**Case #:** ZBA 2018-88  
**Date:** September 17, 2018  
**Recommendation:**

**PLANNING STAFF REPORT**

**Site:** 1 Munroe Street

**Legal Notice:** Applicants and Owners, Enzo J. Orellana and Wesley J. Esser, III, seek Special Permits under §4.4.1 of the SZO to alter a non-conforming structure. Variance for wall/fence height. Unit count will increase from one to two. RA zone. Ward 3.

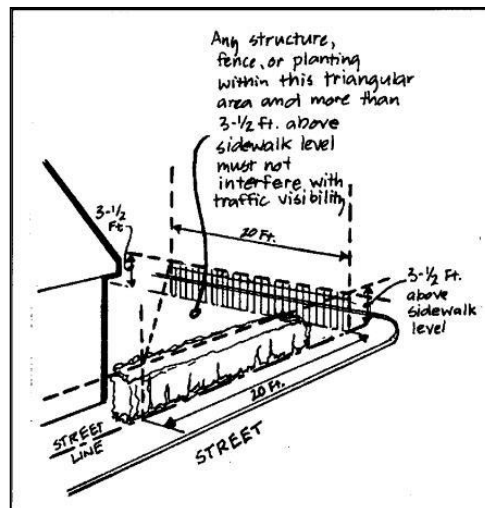
***Staff's response:*** *The locus at 1 Munroe Street gradually slopes down toward Boston Street. The existing rear yard of the property is currently at a higher grade than the existing front yard. The Applicant's proposal to re-grade the front yard further exacerbates the grade differential and, more importantly, the front yard's slope toward Boston Street. Re-grading the front yard will allow for required emergency egress windows to be installed for a bedroom in the new lower-level unit to the left of the front exterior stairwell. Re-grading the front yard will also allow for a main entrance into the lower-level unit to be constructed to the right of the front exterior stairwell. The newly-graded front yard will allow for outdoor living space for the new lower-level unit.*

***Staff response:*** *It may be argued that the Applicants already have reasonable use of the property as a single family and/or that a different design could result in a usable two-family structure that does not call for the installation for a 7-foot front yard privacy wall.*

The SZO calls for front yard fences/walls to be no taller than 3 ½ feet within 20 feet of an intersection. A 4-foot front yard fence is allowed otherwise. A 7-foot front yard wall fronting the public way is inconsistent with the SZO which calls for fences/walls within the 20-foot triangle at an intersection to be no higher than 3 ½ feet. This is illustrated in the diagram below:

*A compromise solution for the portion of the wall that is outside of the above-illustrated triangle may be that the height of the concrete wall is reduced to 6 feet outside of area that is within 20 feet of the intersection. Depending on how the concrete wall is constructed, plantings could be installed along the top of the wall to gain further privacy for the lower-unit yard from those entering and existing through the upper unit exterior stairwell.*
